**FINAL  
ENVIRONMENTAL ASSESSMENT  
\* MAUNALUA BAY DREDGING, OAHU \***

**DEPARTMENT OF LAND AND NATURAL RESOURCES**

**OCEANIT LABORATORIES, INC.**

**October 1998**

FIGURE II-5 DREDGING AREA

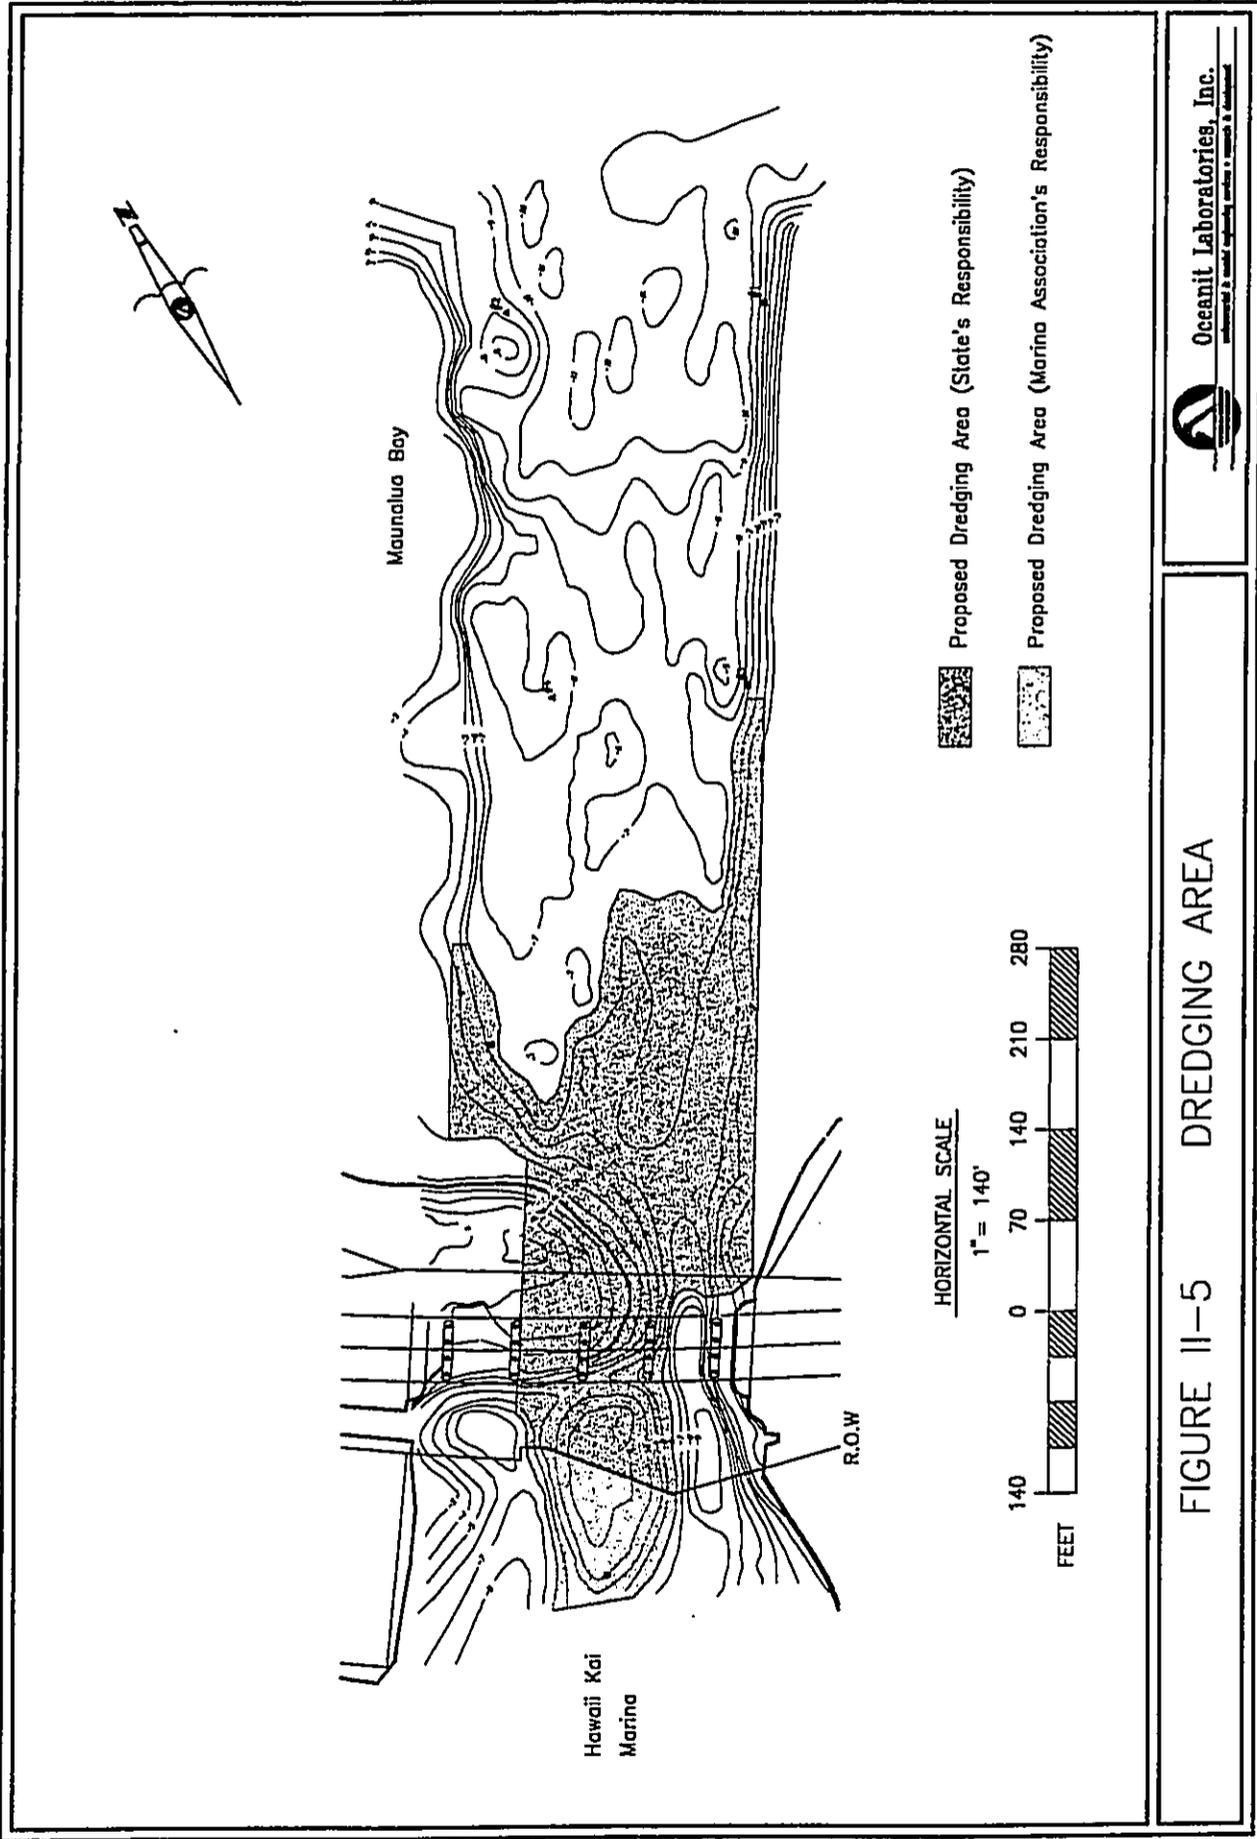
Secondly, the channel area to be dredged is divided into two sections, one section is the responsibility of the state and the other is the responsibility of the Hawaii Kai Marina Association (Figure II-5, page 8). The larger of these sections (state's responsibility) is to be paid for with public funds. OHA questions the wisdom of using solely public funds for an action which will not benefit the general public.

Figure 11-5 shows the area to be dredged by the state and also that to be dredged by the Marina Association. This draft EA appears to address only the dredging to be performed by the state. Will the Marina Association be preparing a separate draft EA document?

FIGURE II-7. BEACH NOURISHMENT AREA

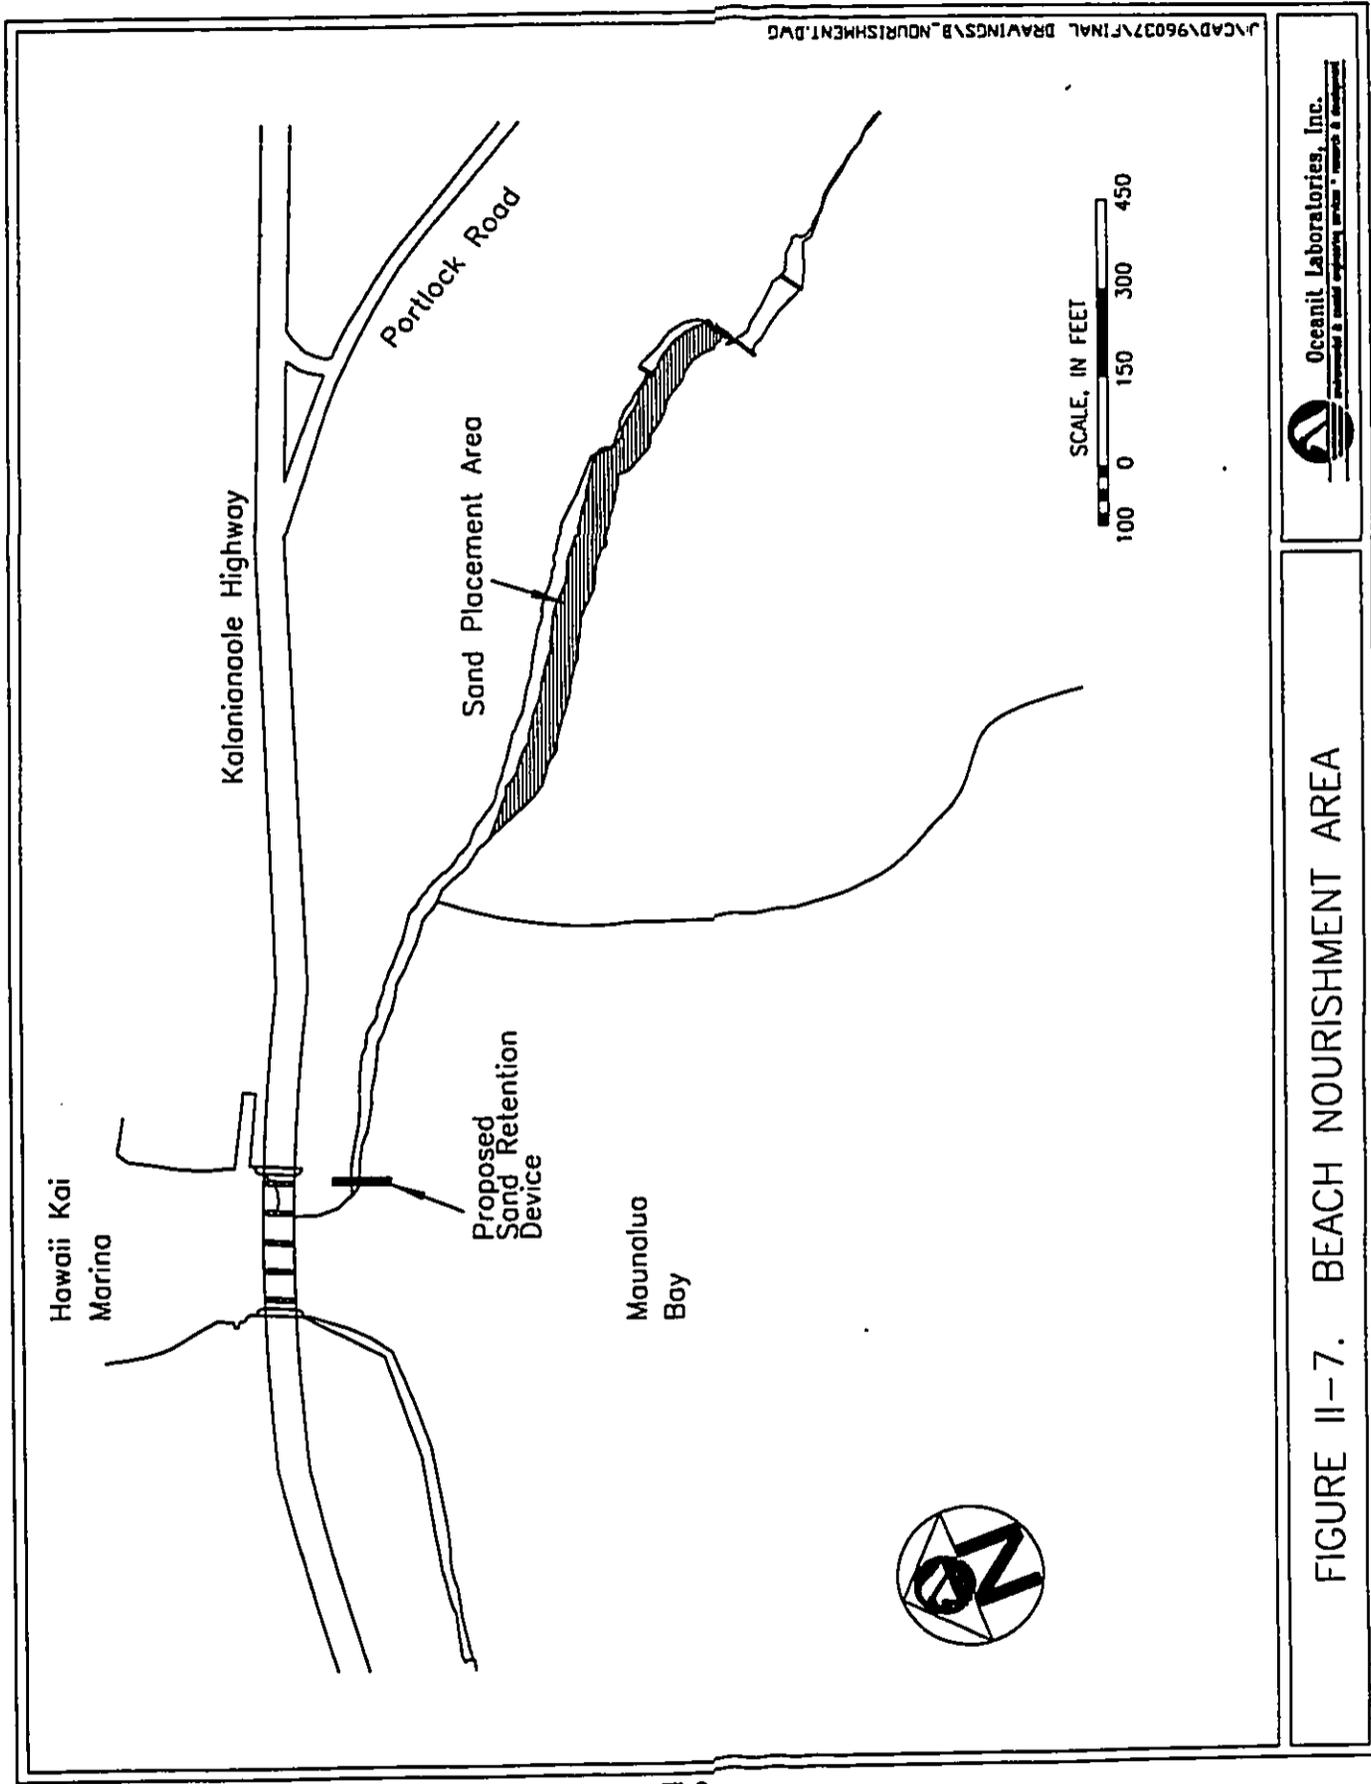
Comment from April 1, 1998 letter:

According to the Oahu Shoreline Study produced by Sea Engineering, Inc., the sand placement area shown in Figure II-7 of the Draft EA eroded between 1974 and 1988. Beach at the north end near the entrance channel has been accreting, most likely from material eroded from the beach just to the south. This erosion/accretion pattern has also been mentioned by residents. An eroded embankment was noted in field trips to the site. Sand will be placed on the eroded shoreline with the knowledge that some of the material will be transported by littoral drift to the north.

FIGURE II-8. SAND RETENTION DEVICE

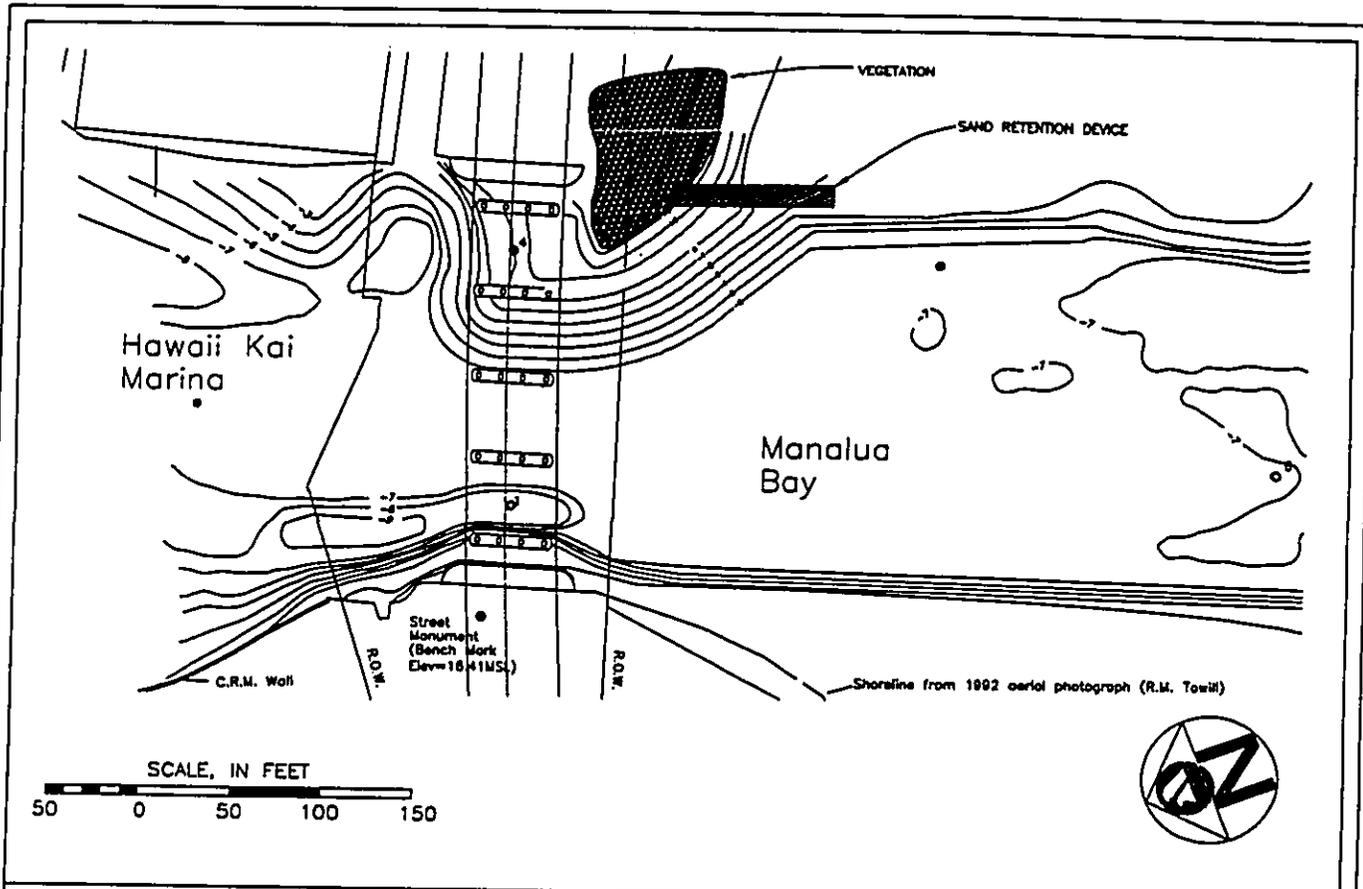
Figure II-8 shows an "artists concept" of the sandbag system. This drawing and

the text does not provide enough information to evaluate the feasibility of this system. The EA should include an engineering drawing and an engineering evaluation addressing at least the following:

- an engineering evaluation for the selection of the optimum height and length of the system. It looks very short in the drawing, and may not retain very much of the sand being moved down the beach. How was the height and length selected. Please show these engineering calculations.

- After beach replenishment how much of the sand will stay on the beach? How much sand is expected to move around the end of the sand bag system? Engineering calculations should be done to show this.

Figure 11-8 illustrates the sand retention device. The draft EA fails to provide rationale behind the engineering design of the groin structure. There appear to be no studies of the magnitude and direction of littoral drift. How were the dimensions of this structure derived? What is the purpose of the round terminal point? How long will it take the sand to clog the channel with and without the structure?

The document under review is an environmental assessment, not a design specification. Engineering calculations are proprietary. Our consultant would be at a competitive disadvantage if his design methods were provided to his competitors. Please realize that a demonstration sandbag groin does not require a lot of complex calculations and is not an optimized structure. Its performance will indicate the need for design modifications.

FIGURE III-2. SEDIMENT AND WATER QUALITY SAMPLE LOCATIONS

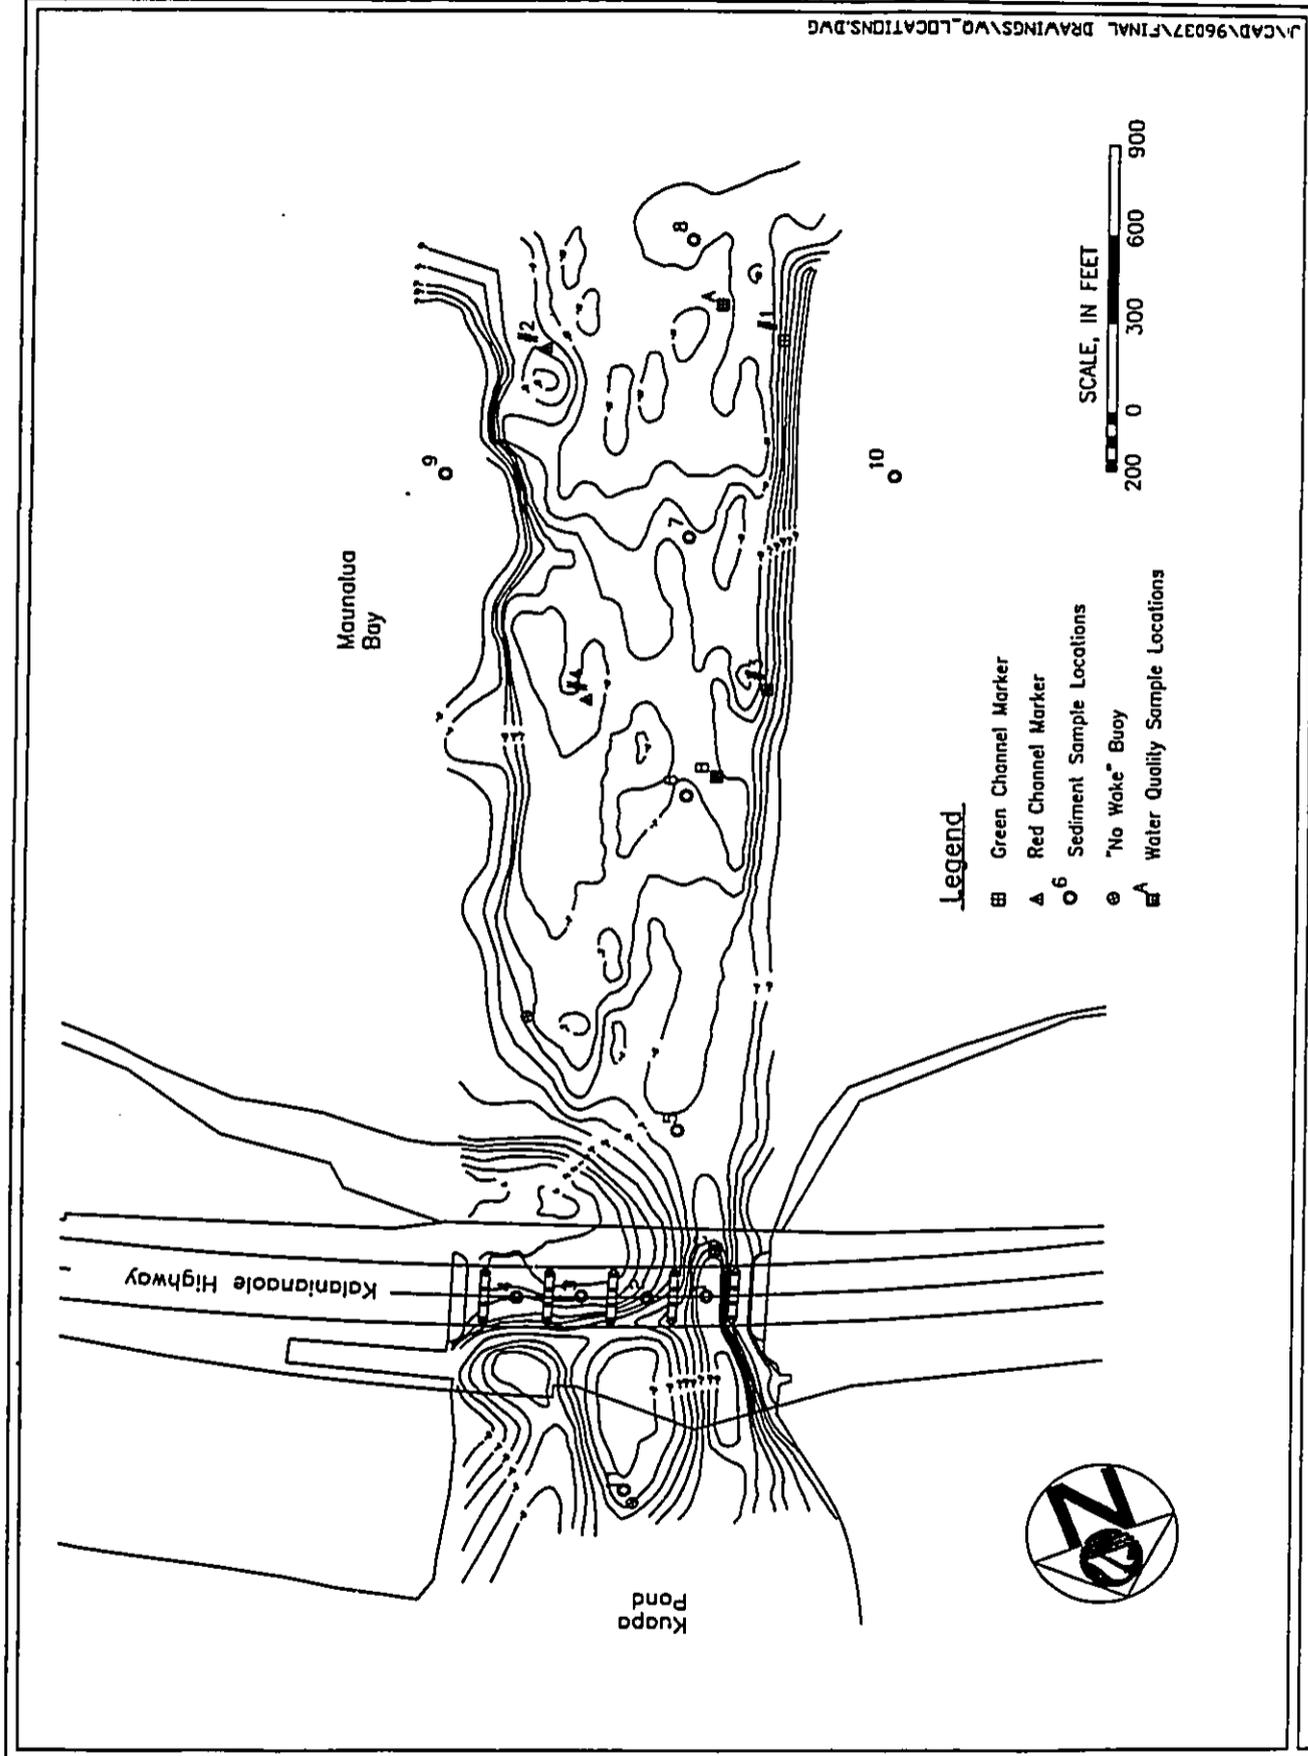
Comment:

Sediment samples were taken at 11 locations shown in Figure III-2 of the EA. These were surface samples. Only those samples taken over 600 feet seaward of the bridge contained high silt content indicating that finer material was carried farther seaward by tidal currents. Those taken in the dredging area under the bridge were above water and were obviously clean white sand similar to the rest of Portlock Beach. Oceanit believes that the tidal currents running beneath the bridge are too fast to allow fine-grained mud, such as that eroded in the flood, to settle.

Figure III-7. Turbidity Data, Hawaii Kai Marina Entrance

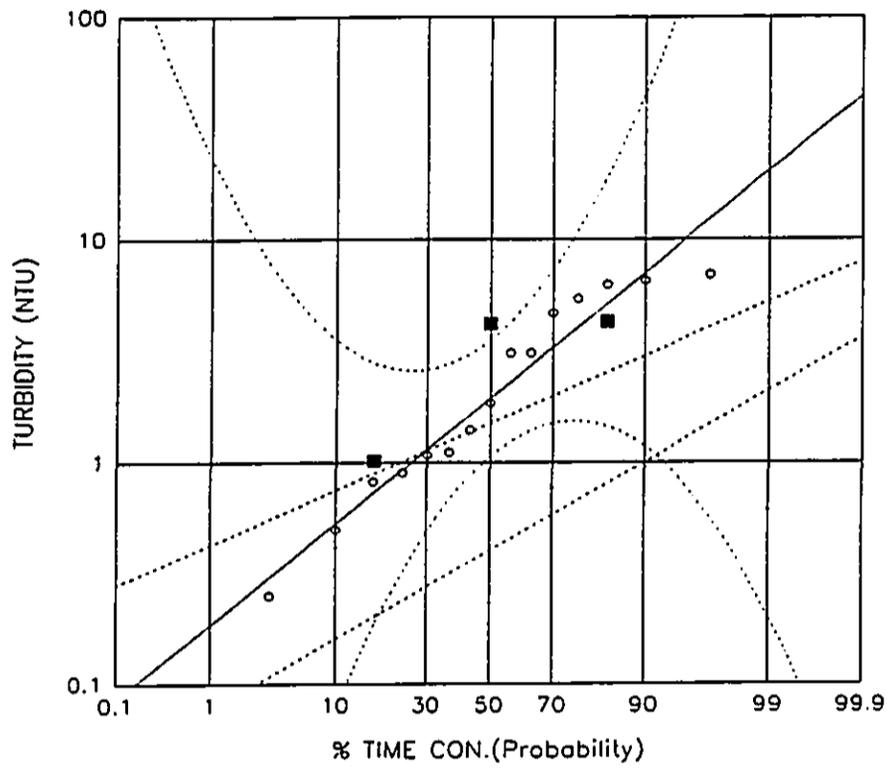
Water quality measurements indicate some fluctuation between values taken in 1973, 1988, and 1996 (Table III-2; and Figure III-7). However, the document fails to mention if the samples were taken on the same tide cycle. Samples taken on an outgoing tide might be quite different than those taken on an incoming tide. The final EA should present water quality data taken on comparable tides.
